National Building Code of Canada 2005

Revisions and Errata

Issued by the Canadian Commission on Building and Fire Codes

Figure A-9.3.2.9.(1)-B

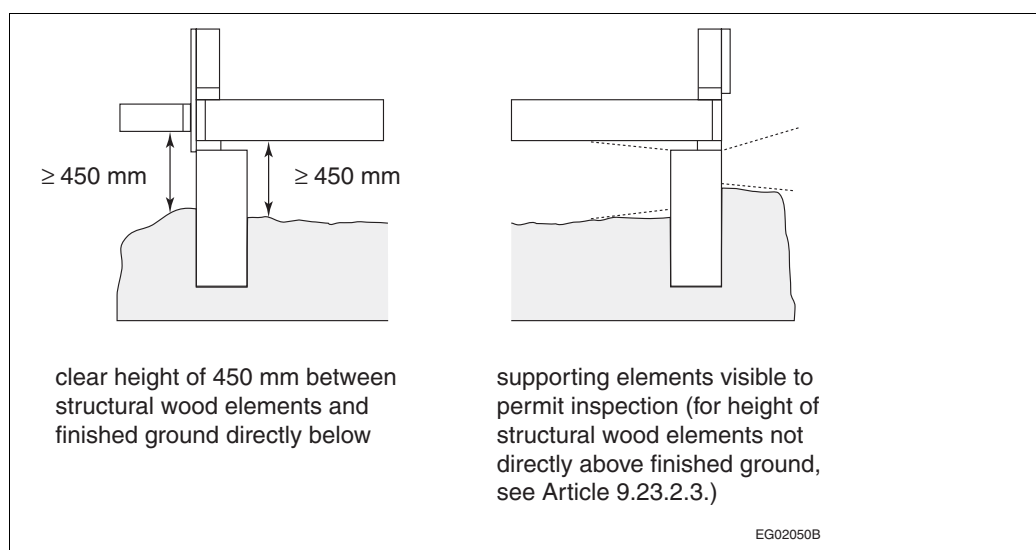
Provision	Erratum	Date of Issue
A-6.2.4.1.(2)(c)	"Carbon Monoxide Alarms" was added as the title of the Appendix Note	07-12-01
Figure A-9.3.2.9.(1)-B	<p>This Figure was replaced with the following one:</p> <div style="display: flex; justify-content: space-around; align-items: flex-start;"> <div style="text-align: center;">  <p>clear height of 450 mm between structural wood elements and finished ground directly below</p> </div> <div style="text-align: center;">  <p>supporting elements visible to permit inspection (for height of structural wood elements not directly above finished ground, see Article 9.23.2.3.)</p> <p>EG02050B</p> </div> </div>	07-12-01
Appendix C, Table C-2	Entry for Yukon, Whitehorse under column heading Seismic Data: value of $S_a(1.0)$ was changed to 0.10	07-12-01
Division C, Volume 1
